GALLERIA LANDINGS

DEPARTMENT OF SUSTAINABLE DEVELOPMENT - URBAN DESIGN AND PLANNING
DEVELOPMENT REVIEW COMMITTEE SITE PLAN

1180 N. FEDERAL HIGHWAY
FORT LAUDERDALE, FLORIDA

FLOOR PLAN LEVEL -01

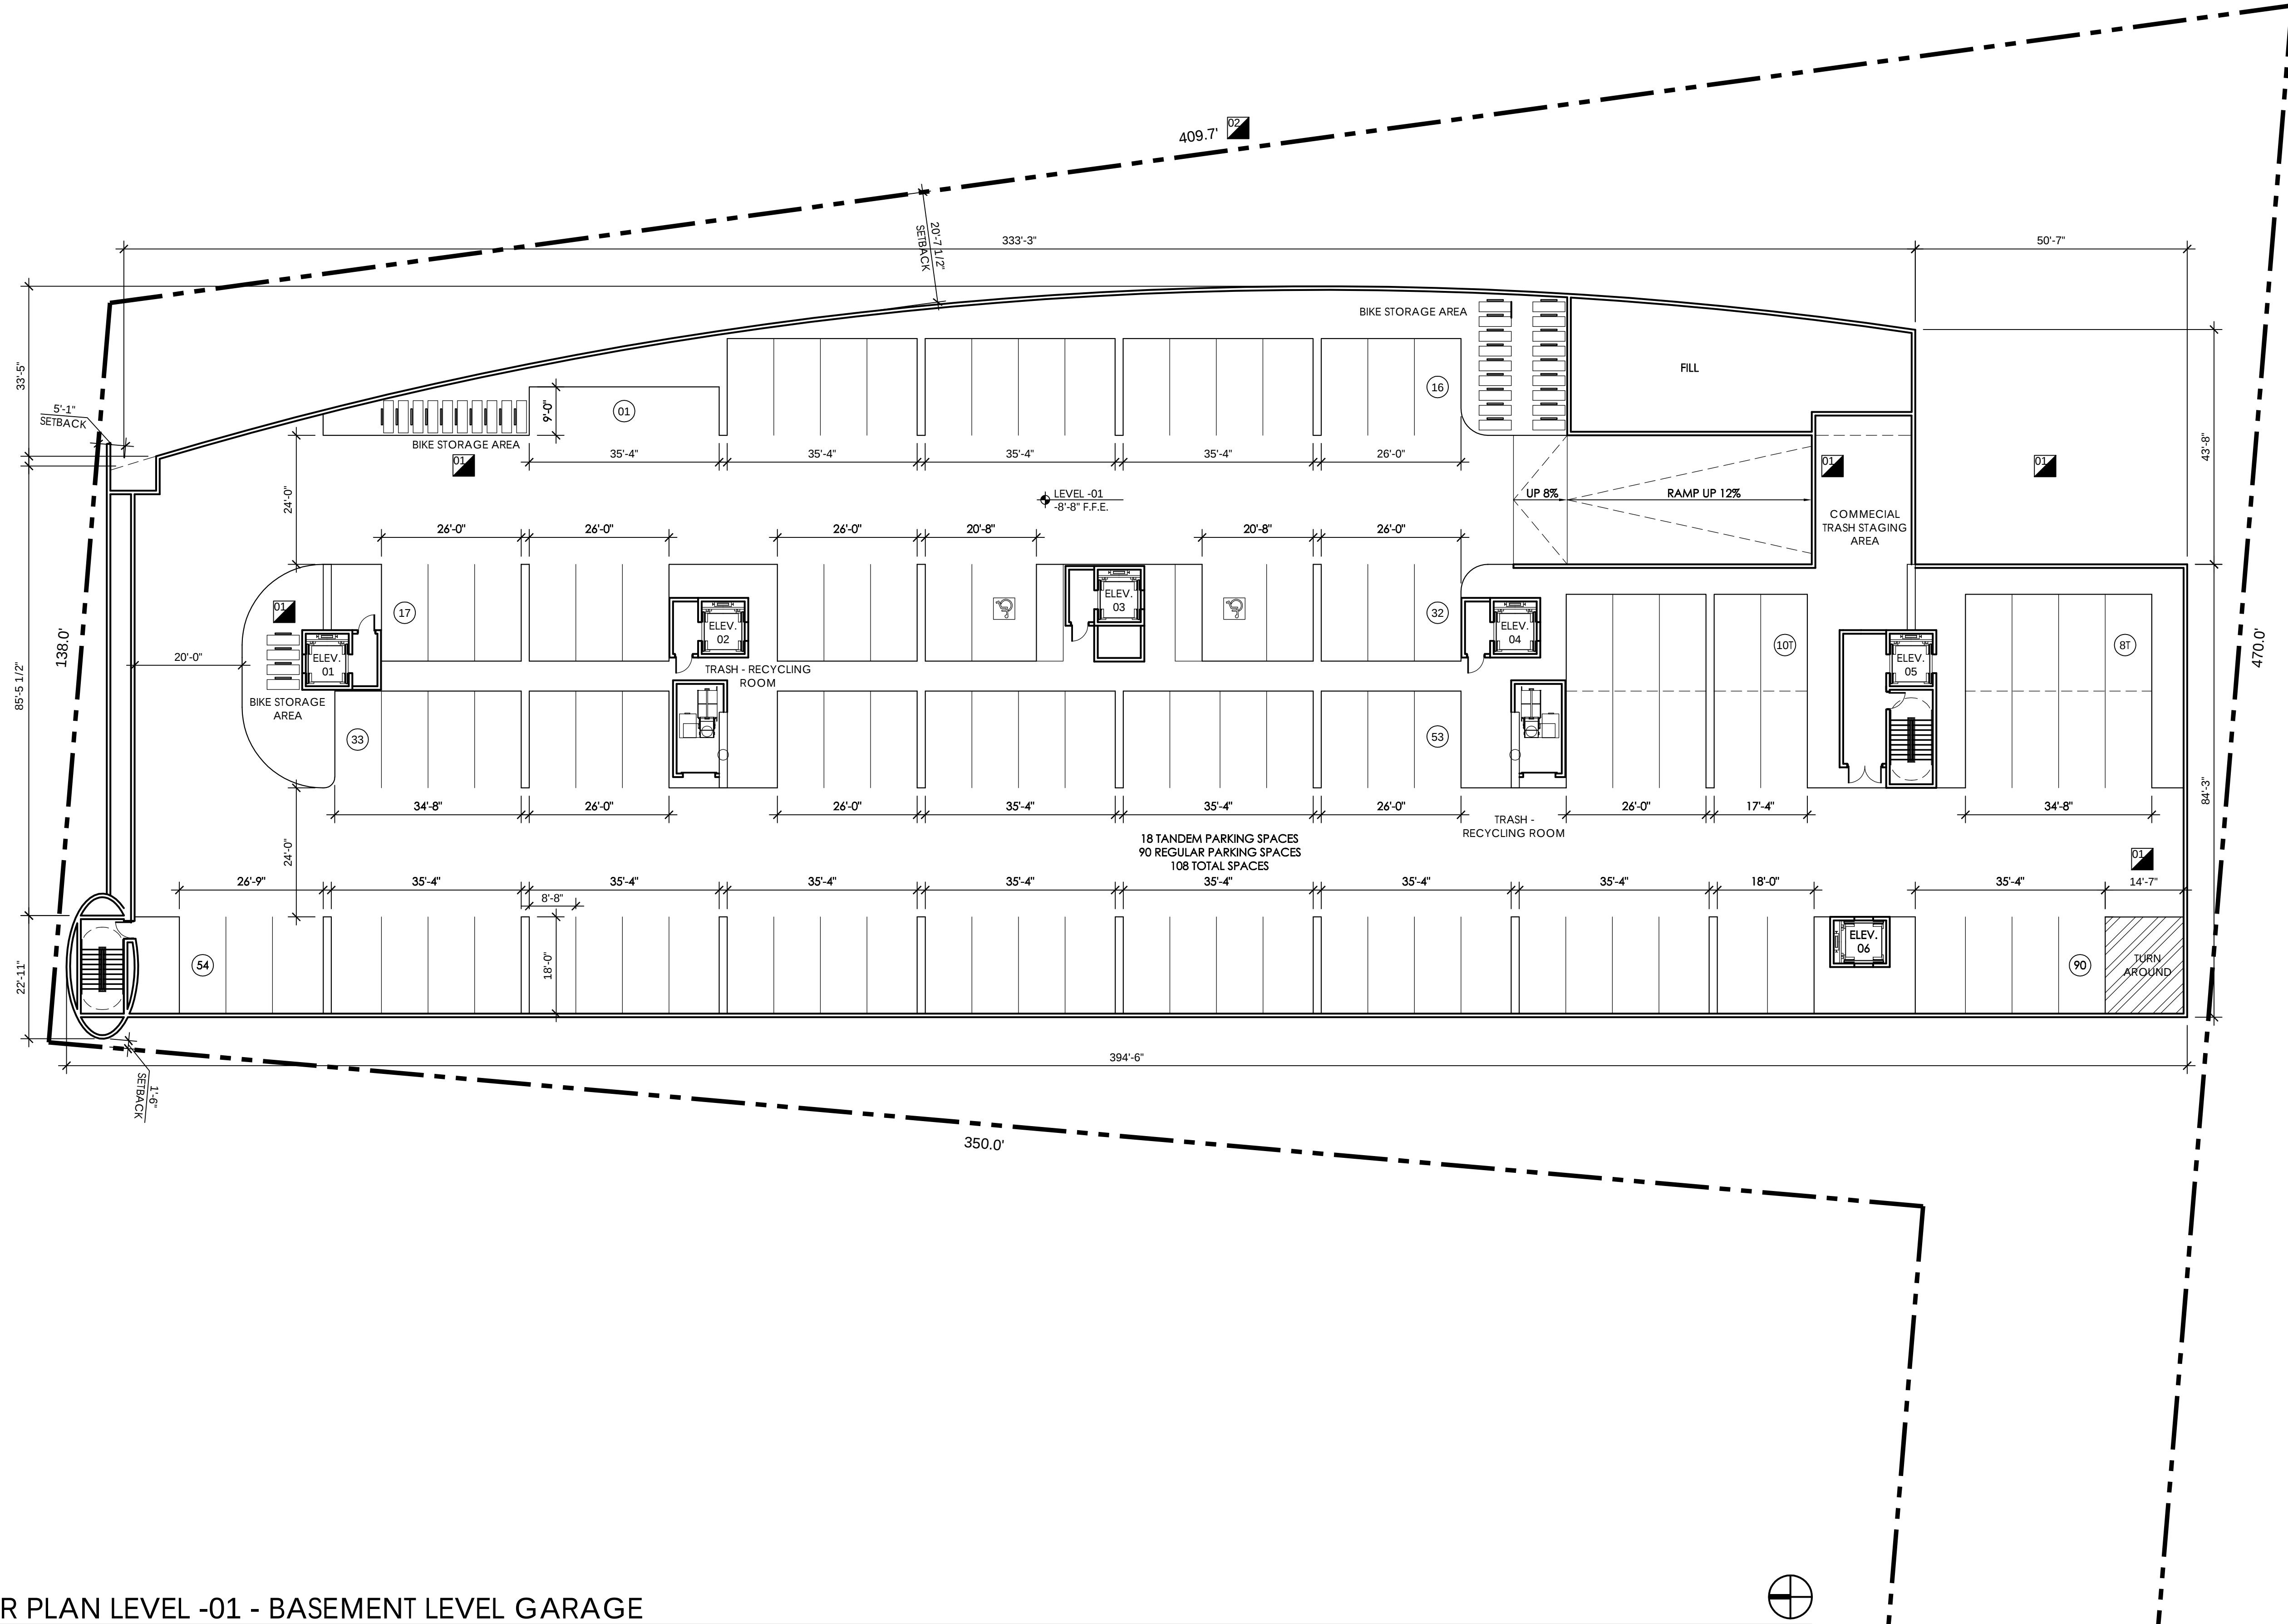
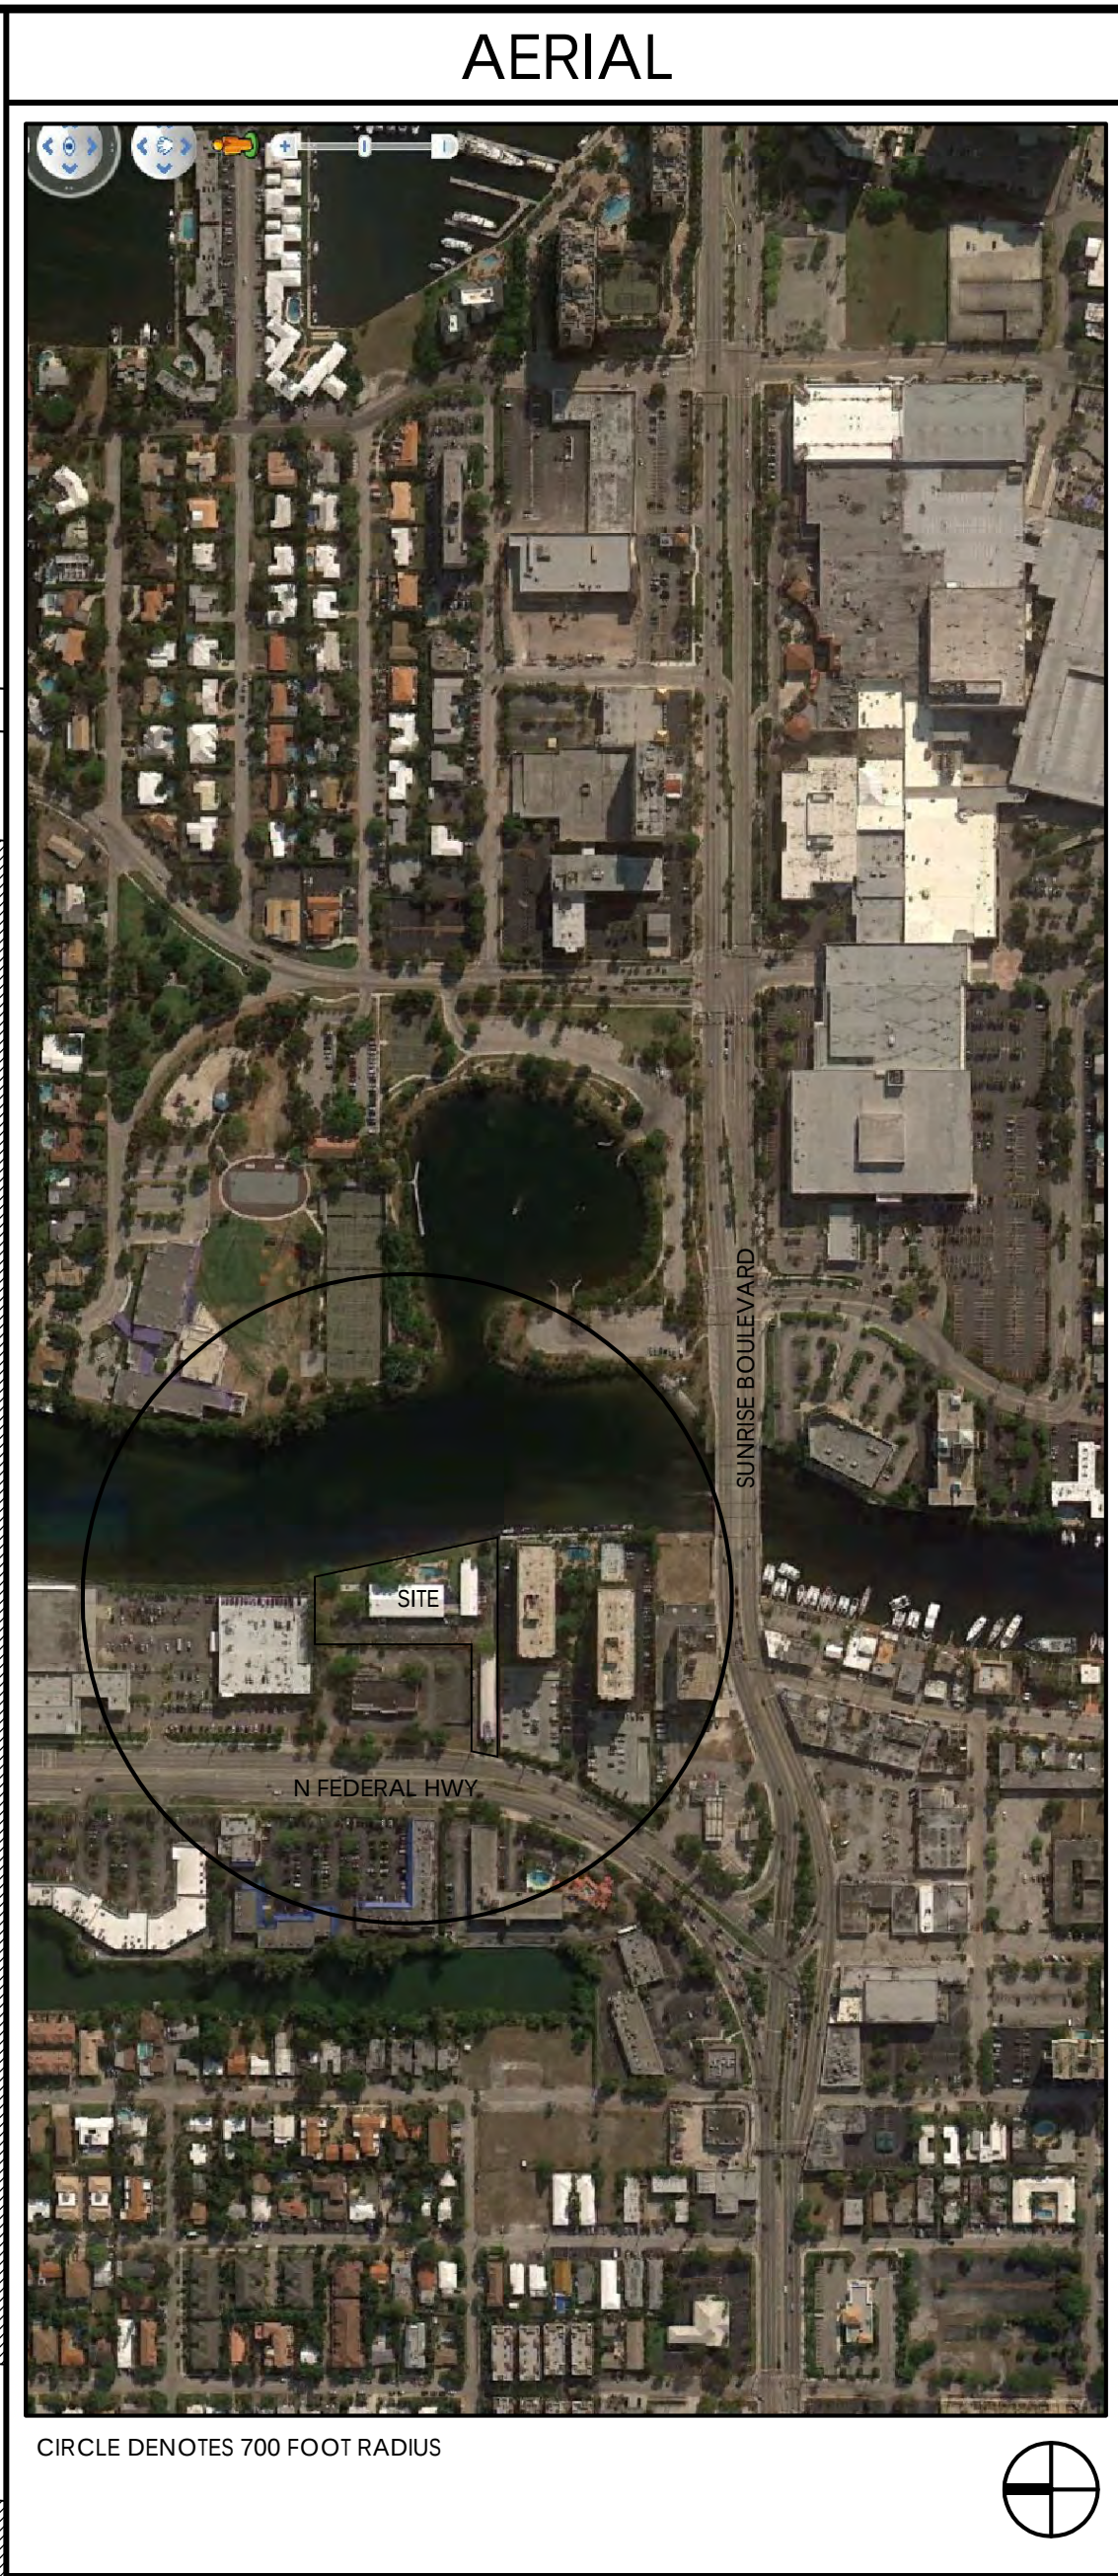
01 DRC COMMENTS
TURN AROUND LABELED
GARAGE REVISION TO EXTEND PUBLIC
PLAZA AREA
COMMERCIAL TRASH STAGING AREA
ADDED
SECURE BIKE STORAGE AREA ADDED
02 DIMENSION CORRECTED
